SUBJECT: Forwards responses to NRC 810821 ltr requesting info re
 pressurized thermal shock. Detailed rept will be submitted
 by 820115.

Subject: Oconee Nuclear Station, Unit 1
Docket No. 50-269
Pressurized Thermal Shock

Response to NRC letter dated August 21, 1981
Request for Information

ENCLOSURE I

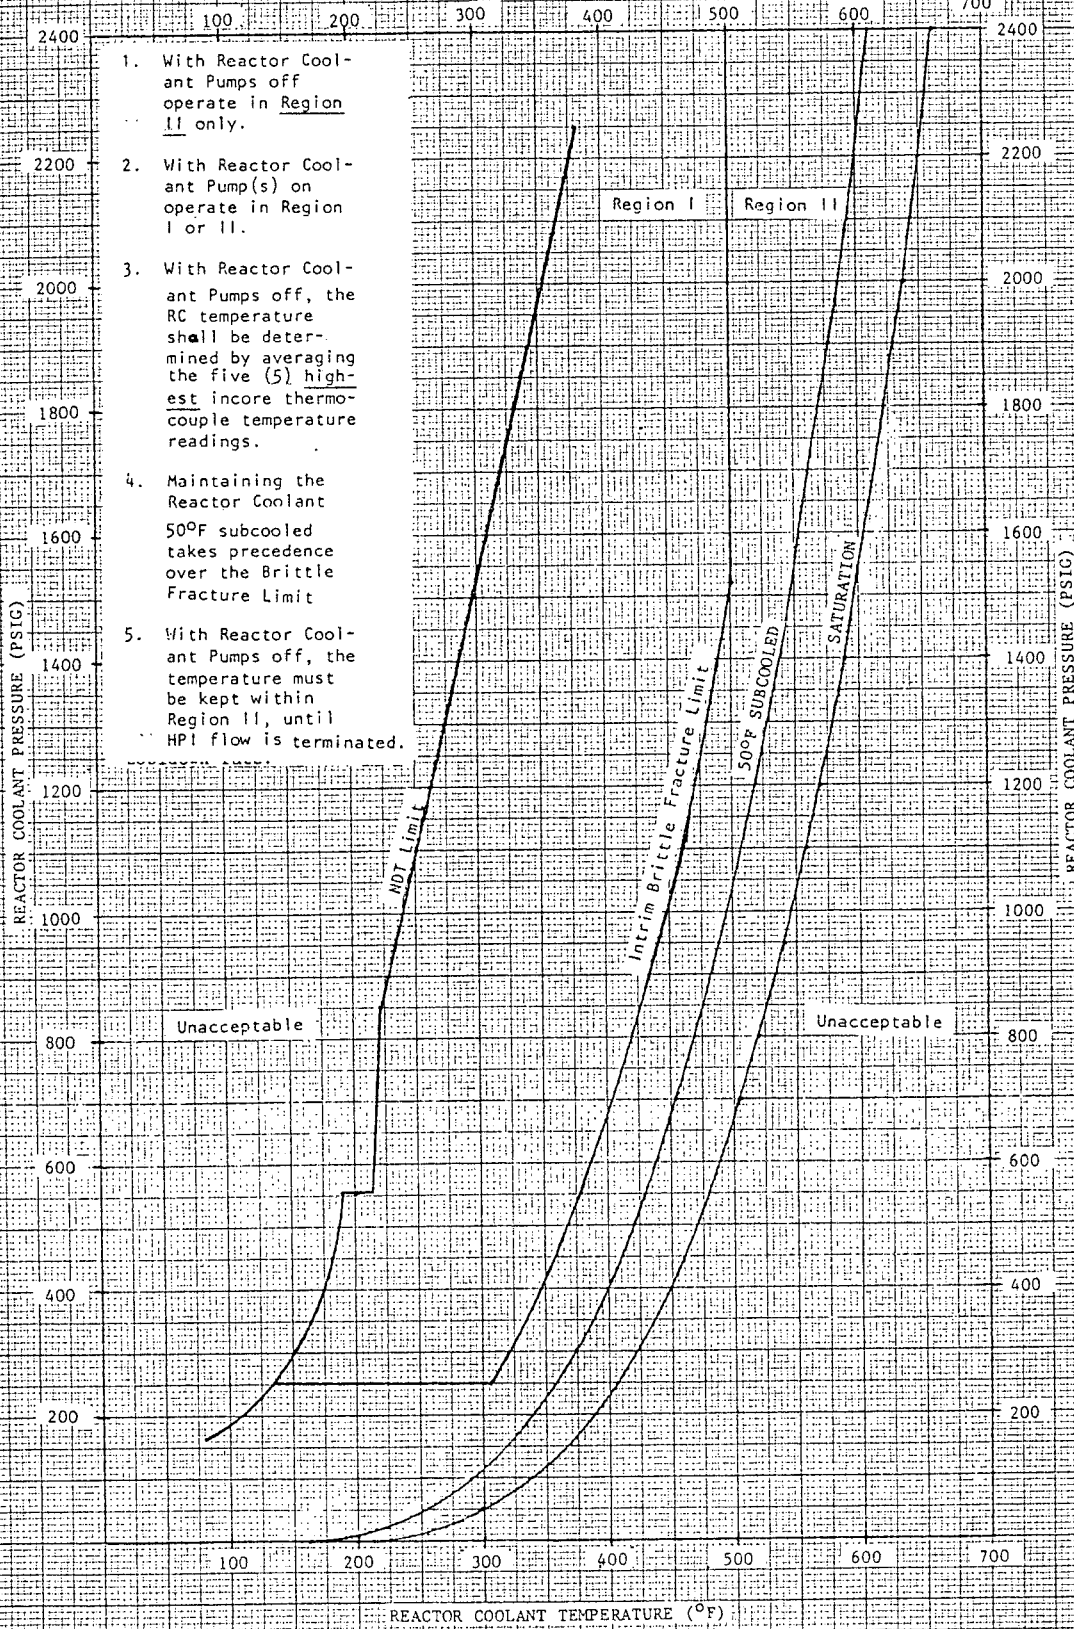
- (5) Provide a listing of operator actions which are required for your plant to prevent pressurized thermal shock and to ensure vessel integrity. Include a description of the circumstances in which these operator actions are required to be taken. Included in this summary should be the specific pressure, temperature and level values for: a) high pressure injection (HPI) termination criteria presently used at your facility, b) HPI throttling criteria and instruction presently used at your facility, and c) criteria for throttling feedwater presently used at your facility. For each required operator action, give the information available to the operator and the time available for his decision and the required action. State how each required operator action is incorporated in plant operating procedures and in training and requalification training programs.

For the loss of coolant, the emergency procedures provide for HPI throttling and termination. Throttling of HPI flow is permitted, if the RCS is 50°F subcooled, to keep the reactor coolant system (RCS) pressure/temperature in the appropriate region of the attached curve (Enclosure 1). If the High Pressure Injection system actuated because of low RCS pressure, it is required to remain in operation until one of the following criteria is satisfied:

- 1) The LPI System is in operation and flowing at a rate in excess of 1000 gpm in each line and the situation has been stable for 20 minutes; or
- 2) All hot and cold leg temperatures are at least 50°F below the saturation temperature for the existing RCS pressure (see Enclosure 1), and the action is necessary to prevent the indicated pressurizer level from going off scale high.

1. With Reactor Coolant Pumps off operate in Region II only.
2. With Reactor Coolant Pump(s) on operate in Region I or II.
3. With Reactor Coolant Pumps off, the RC temperature shall be determined by averaging the five (5) highest incore thermocouple temperature readings.
4. Maintaining the Reactor Coolant 50°F subcooled takes precedence over the Brittle Fracture Limit
5. With Reactor Coolant Pumps off, the temperature must be kept within Region II, until HPI flow is terminated.
